**Technical Service
BULLETIN**

REAR QUARTER PANEL PAINT CHIP PROTECTION

'95 – '00 Tacoma

BODY
BO001-00

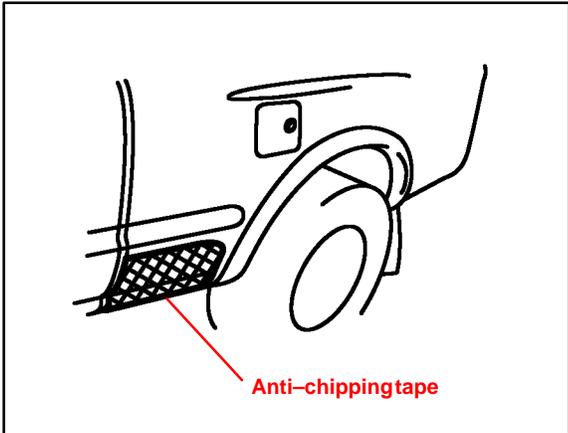
Introduction A new anti-chip tape has been developed to help prevent repeat occurrences of paint chipping on the rear quarter panels of Tacoma compact pick-up trucks caused by the impact of road debris.

Apply the anti-chipping tape directly to the painted surface of the rear quarter panel between the front edge of the rear quarter panels and the rear tires as shown.

NOTE:
This repair is to be used in conjunction with repainting of the truck bed due to excessive chipping of the rear quarter panel.

NOTE:
Apply anti-chipping tape only after the surface has been repainted, cured, and is not hotter than 38°C (100°F).
